**ADDENDUM NO. 1
TO
BID DOCUMENTS FOR
CONSTRUCTION OF THE NICHOLSON LANDFILL GROUNDWATER
TREATMENT FACILITY UPGRADES
FOR
COUNTY COMMISSIONERS OF KENT COUNTY, MARYLAND**

The following changes, additions, and/or deletions shall be made to the Bid Documents for the Construction of the Nicholson Landfill Groundwater Treatment facility Upgrades for the County Commissioners of Kent County, Maryland.

Kent County Groundwater Treatment Upgrades for the Nicholson Landfill Pre-Bid Meeting Agenda

Proposed Designated Material Layout Area (Approximately 3,300 sq. ft.)

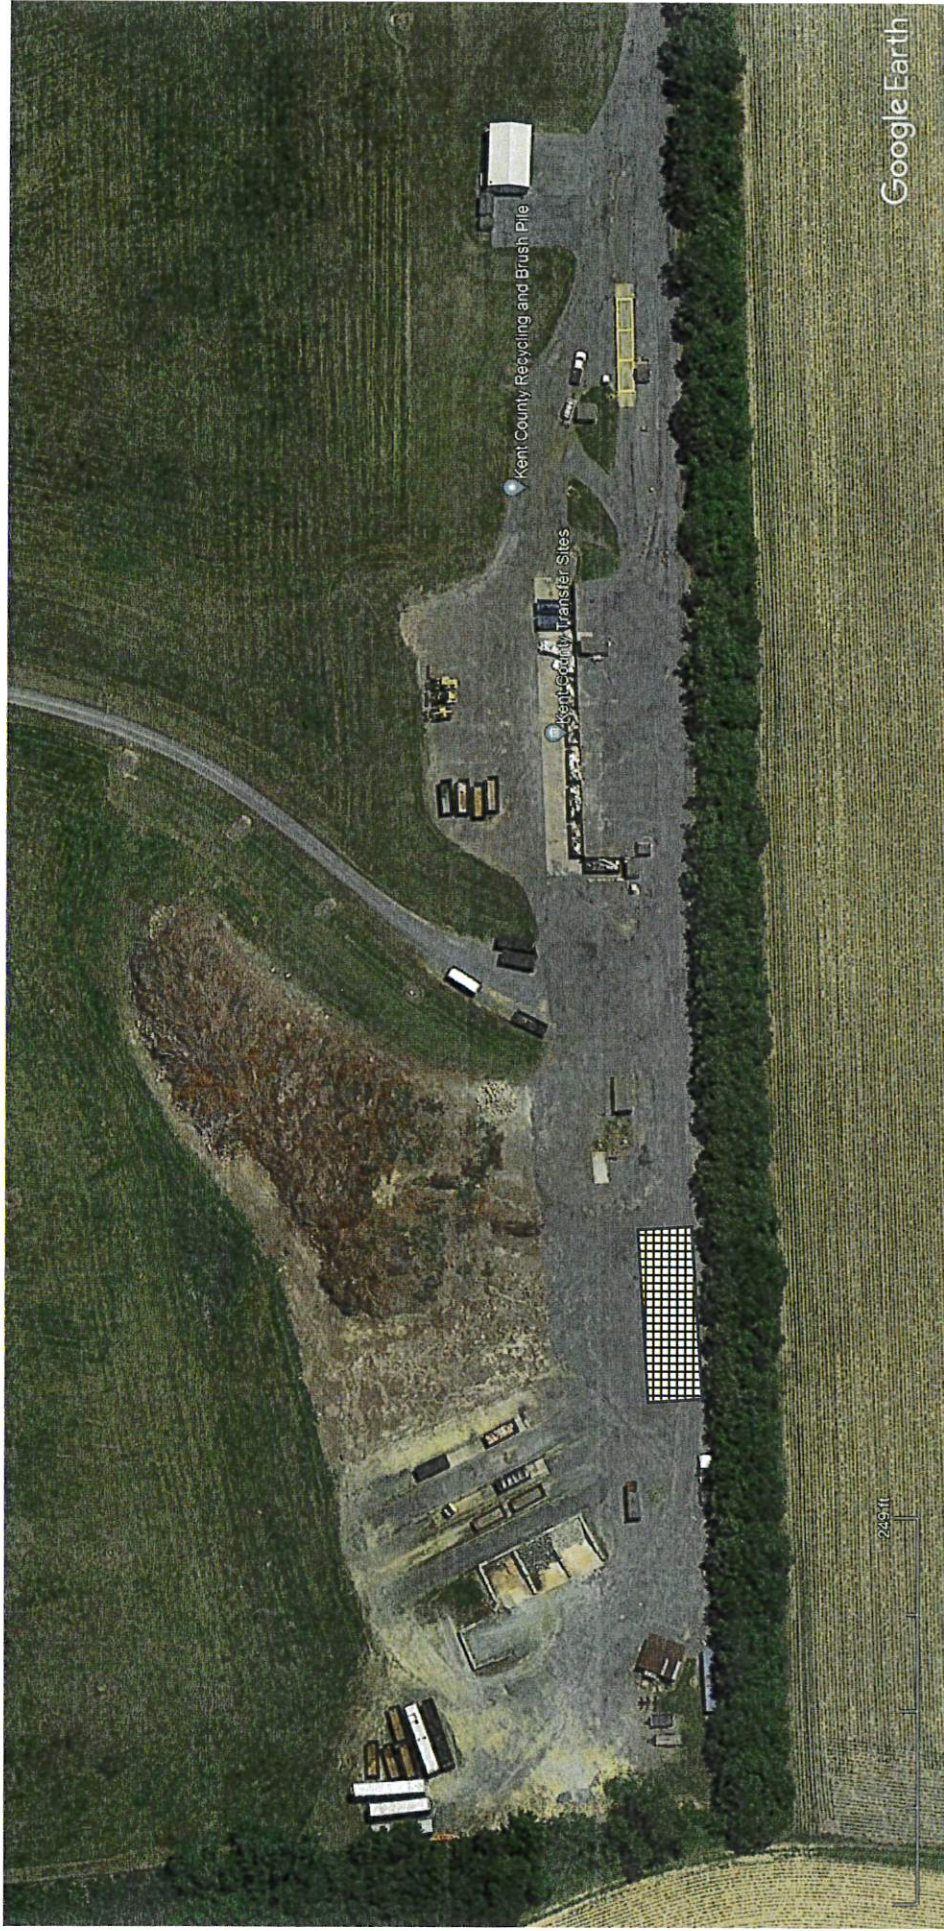
There was a question about available area for material layout for the project.

Attached is an aerial view of another portion of the Nicholson Landfill with a designated layout area.
